RotorSport UK Ltd

Service Repair Request and Evaluation/Approval

Repair No.: 003	CCAR No.: None Mod approval No. MC-086	Repair classification: MAJOR MINOR
Aircraft type: MT-03	Aircraft serial No.: OPEN

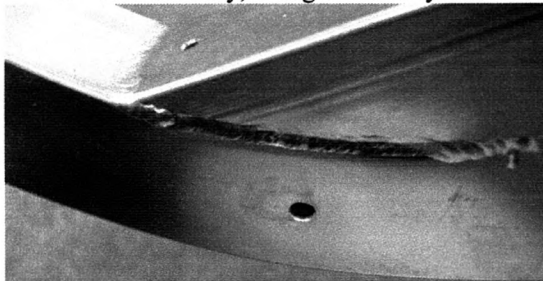
Foreword; Two holes are drilled through the lower keel tube of the MT-03 in order to pass the bolts through that holds the rudder cable pulleys to the keel. The hole needs to be square to the keel in order for the pulley to sit without rubbing on the side of the keel. The hole was drilled through from each side up to approximately Jan 2008, a process that could induce variance in the hole position if the drill wandered or the hole position was incorrectly marked.

Due to an established, but not approved, repair process within the AutoGyroworkshop, such a positional error was either corrected by slotting the hole or by welding the hole and re-drilling.

Example of welded and re-drilled hole

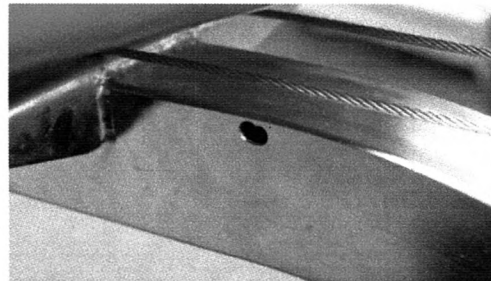
(where a hole has been drilled offset and requires repositioning – assumes not assembled with mating parts)

1. Using filler metal suitable for 1.4301 stainless steel, carefully weld edge of hole. Maintain as far as practical, the wall section of 2mm or more. Weld distance to suit requirement for re-drilling.
2. Allow to cool, and using the jig, re-drill the hole. Check for correct alignment.
3. Document that the process has been carried out within the airframe documentation.
4. Alternatively, a single hole may be slotted to a maximum width of 10mm
